August 19, 2021

Re: Final Engineer's Report (FER) for the Proposed Improvement of Lyon County Ditch 14

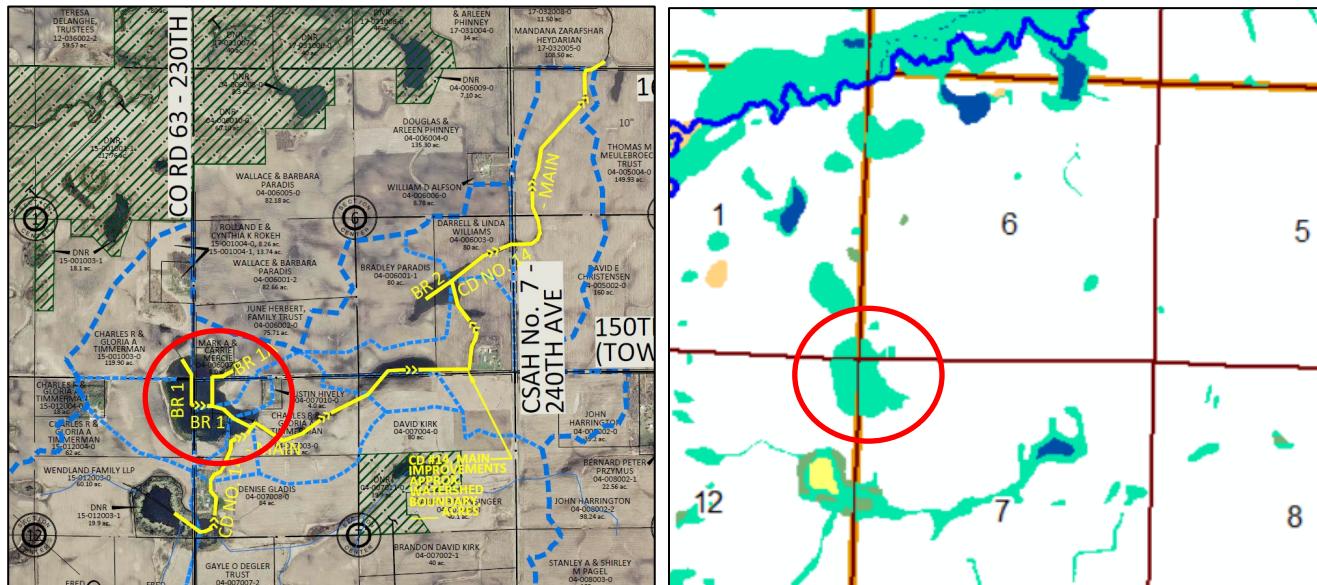
In addition to significantly increasing the drainage capacity of this system, this project proposes to substantially improve drainage in several observable water holding areas on the landscape (see below image, left, yellow lines). Some of these areas are identified in the National Wetlands Inventory (see below image, right), particularly the large wetland shown circled below in both images. The FER plans call for perforated pipe to be installed under this circled NWI wetland (page C5.07). Perforated pipe would drain this NWI wetland.

The FER states that no impacts to wetlands will occur from this project due to the use of non-perforated pipe “through, and near, these wetlands”. However, as mentioned above, this design includes perforated pipe under the circled NWI wetland in addition to under other observable water storage areas as well as open intakes in potential wetland areas. The FER needs to be revised to include a map illustrating WCA protected wetlands and specifically where non-perforated pipe is required. Non-perforated pipe must be used within the lateral drainage effect zone of the tile on any wetlands, and engineering analysis (i.e. Van Schilfgaarde equation) needs to be completed to identify and map these areas. In lieu of additional analysis, non-perforated pipe can be used throughout the project. The design should also review the use of open intakes, and ensure no open intakes or other drainage system features will impact wetlands.
